# REGIONAL REVIEW NOTICE

**ARC REVIEW CODE:** R1606271

**Name of Proposal:** Locust Grove - Clayco

**Description:** This DRI is located in the City of Locust Grove on Price Road, north of Bill Gardner Parkway and west of Interstate 75. The proposed project consists of a 1,002,998 sq. ft. high-cube warehouse and distribution facility in one building on 79.4 acres. The planned build-out of this development is 2018. The trigger for this DRI review is a rezoning application filed with the City of Locust Grove.

DRI PLAN  
LOCUST GROVE - CLAYCO  
HENRY COUNTY, GA  
APRIL 8, 2016

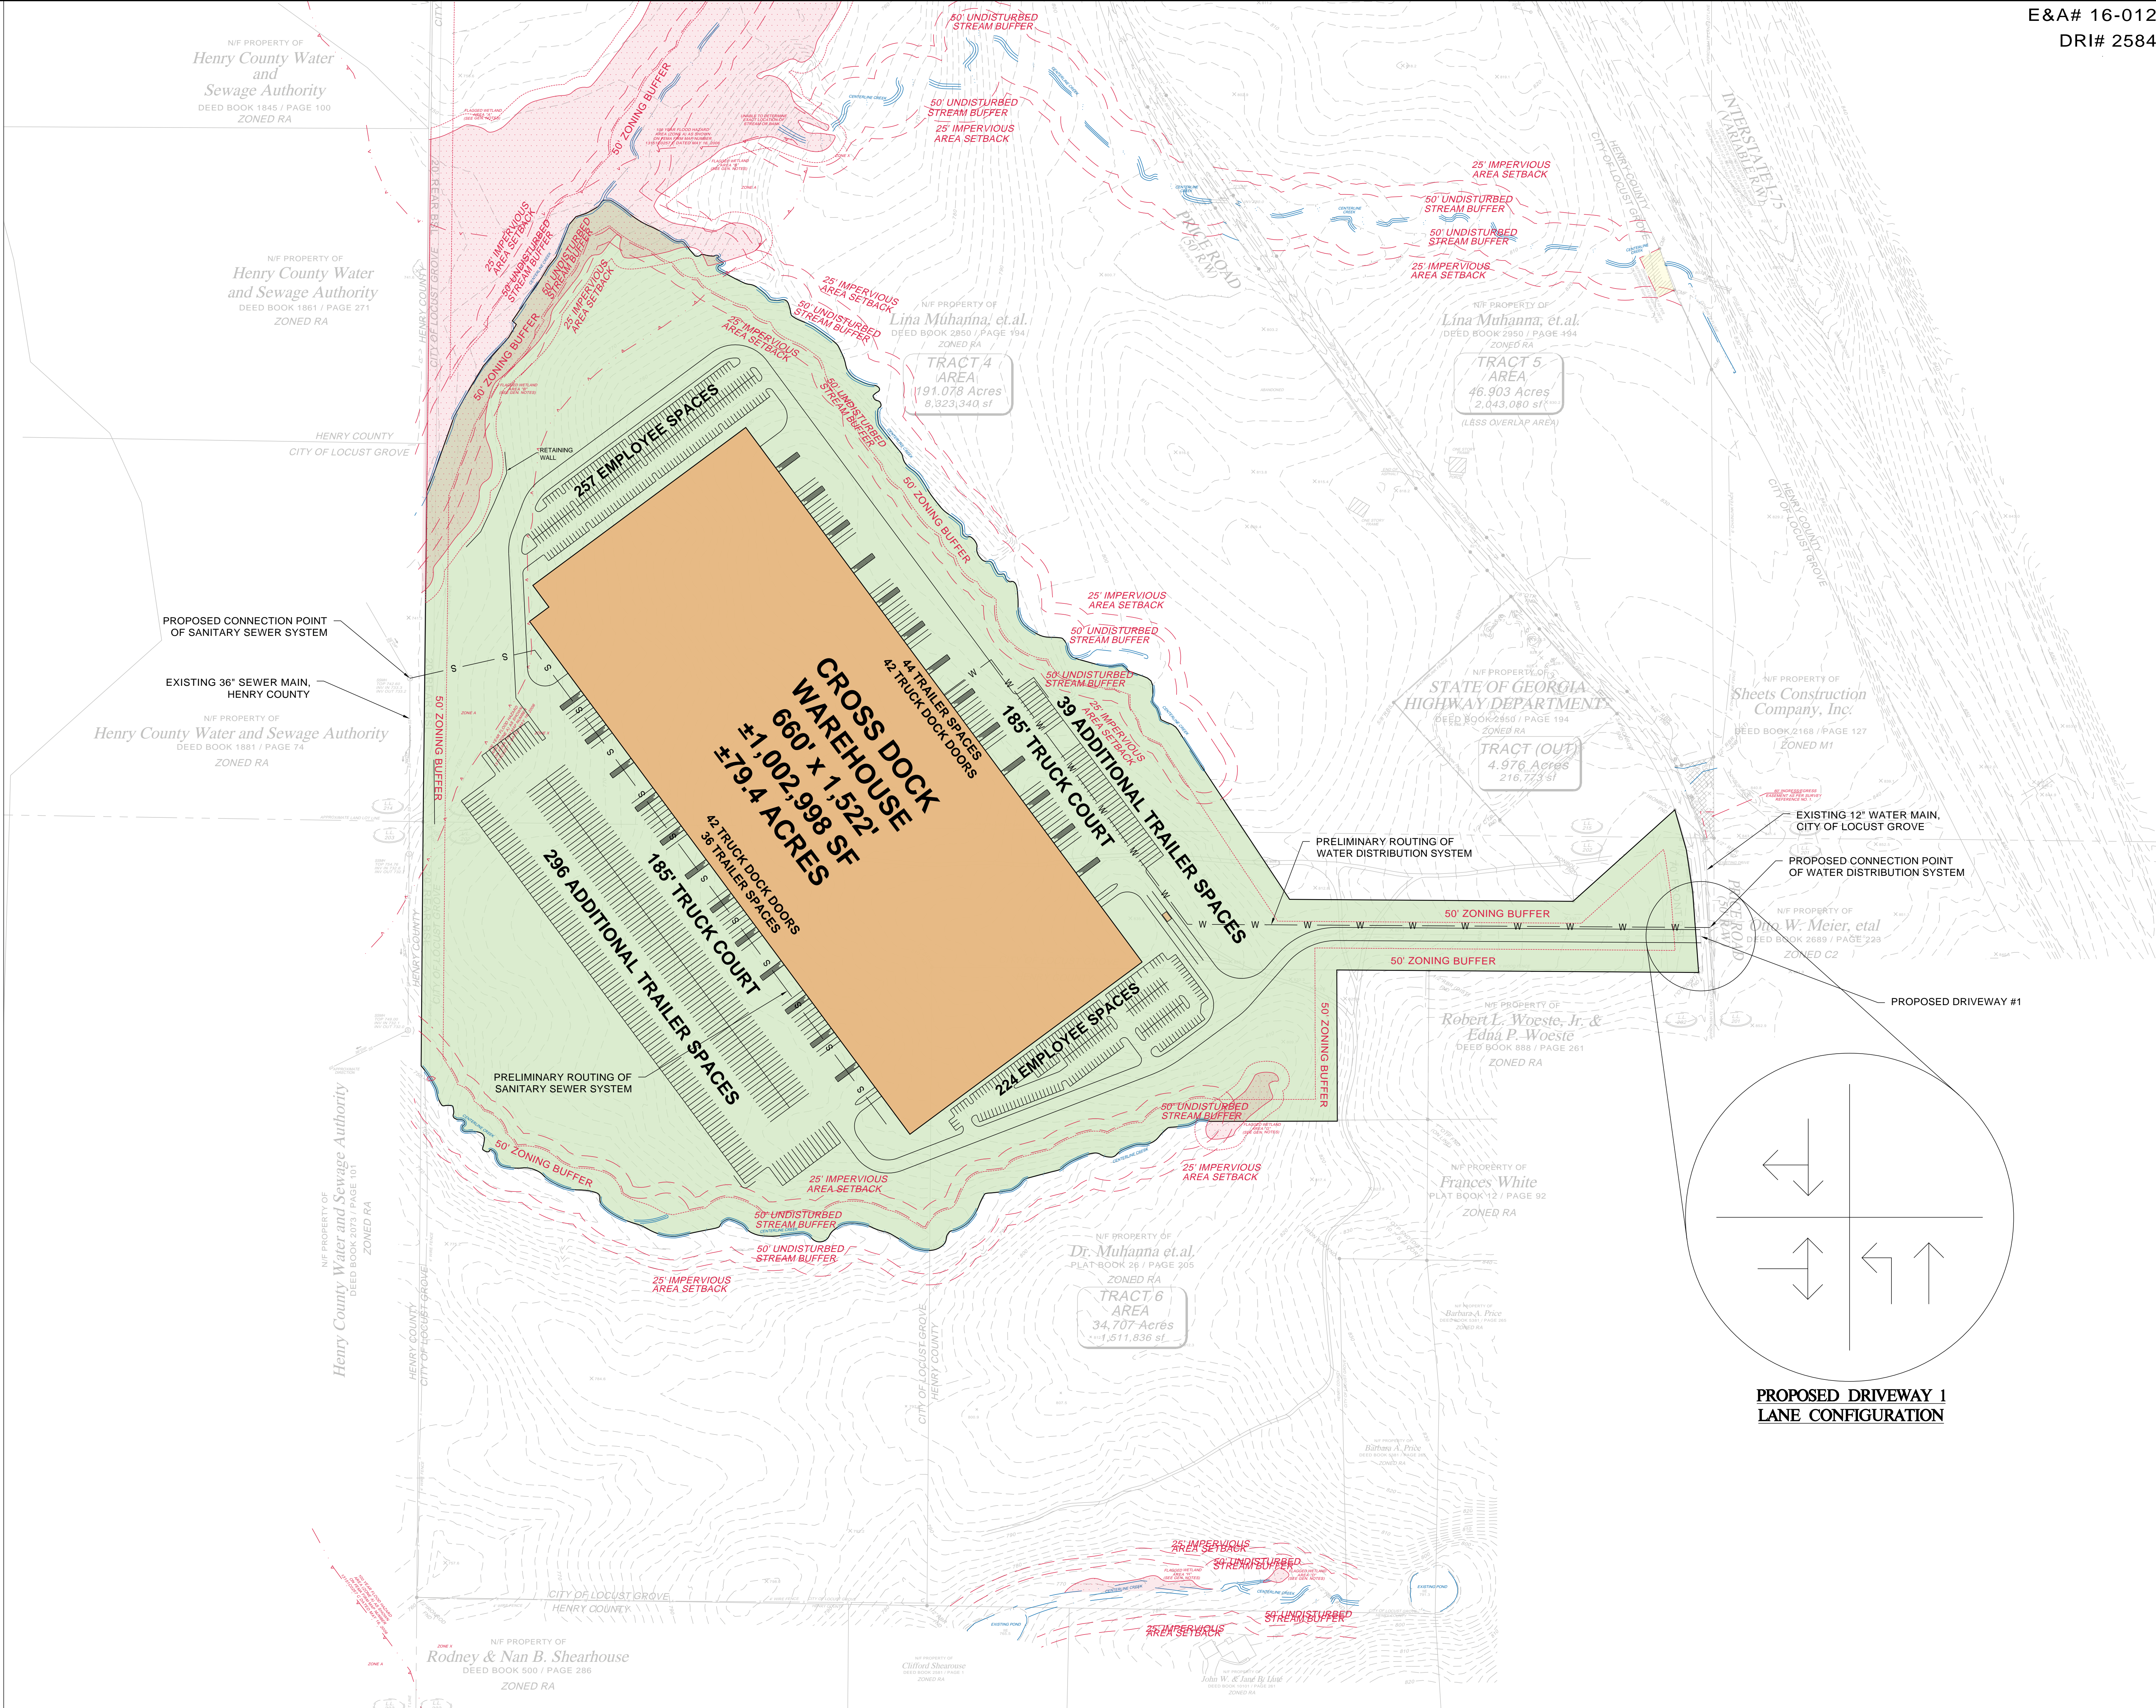
The submitted site plan shows streams along the northeast, northwest and southern boundaries of the project property, with 50-foot undisturbed buffers and additional 25-foot impervious surface setbacks (75-foot total) on all of them. No proposed development is shown within the buffers on the project plans. The USGS coverage for the project area also shows the streams as blue-lines and also shows them as tributaries of Indian Creek, which is west of the project property.

The project plans also show stream 100-year floodplain in the northern portion of the property, as well as wetland areas at the northern edge of the property. These areas will be subject to all applicable US Army COE requirements under Section 404 of the Clean Water Act as well as any City floodplain and wetland requirements. The wetland areas as well as all other waters of the state on the property, including the mapped streams, are also subject to the State Erosion and Sedimentation Act requirements, which include buffers.
